AMENDMENT OF SOLICITATION/MODIFICATION OF CONTRACT		1. CONTRACT ID CODE		PAGE OF PAGES 1 8	
2. AMENDMENT/MODIFICATION NO. 000001		3. EFFECTIVE DATE 06/16/2011		4. REQUISITION/PURCHASE REQ. NO.	
5. PROJECT NO. (If applicable)		6. ISSUED BY NASA/John F. Kennedy Space Center Office of Procurement MAIL CODE OP KENNEDY SPACE CENTER FL 32899		7. ADMINISTERED BY (If other than Item 6) NASA/Kennedy Space Center Office of Procurement MAIL CODE OP KENNEDY SPACE CENTER FL 32899	
8. NAME AND ADDRESS OF CONTRACTOR (No., street, county, State and ZIP Code)		(x) 9A. AMENDMENT OF SOLICITATION NO. NNK1138429R		9B. DATED (SEE ITEM 11) 06/16/2011	
CODE		FACILITY CODE		10A. MODIFICATION OF CONTRACT/ORDER NO.	
				10B. DATED (SEE ITEM 13)

The Purpose of this Solicitation Amendment is to answer bidder questions.
Receipt of Proposal date is NOT extended.

Section 1 Question and Answers

8. REFERENCE: Drawing 584F0301001, SHEETS V-1A, M-1, V-3, V-4

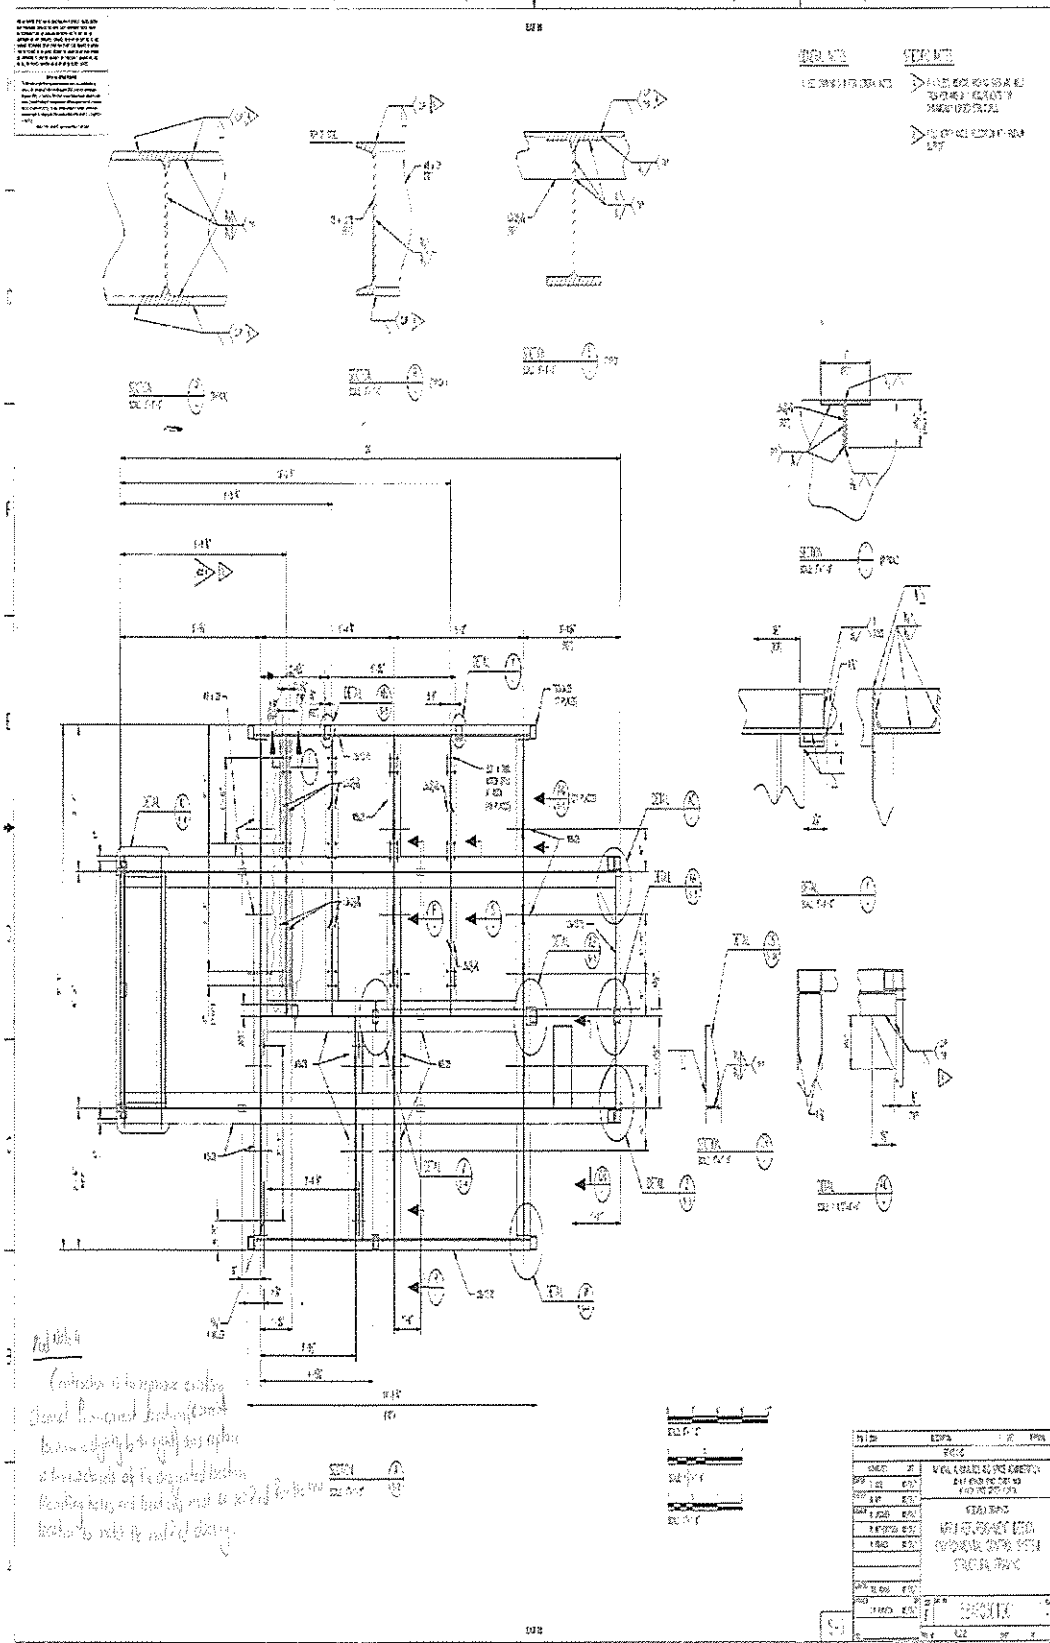
QUESTION: Does mod 26 apply to sheet V-4 in addition to sheets M-1 and V-3 in regards to flag note A?

ANSWER: *YES. The omission was not intentional.*
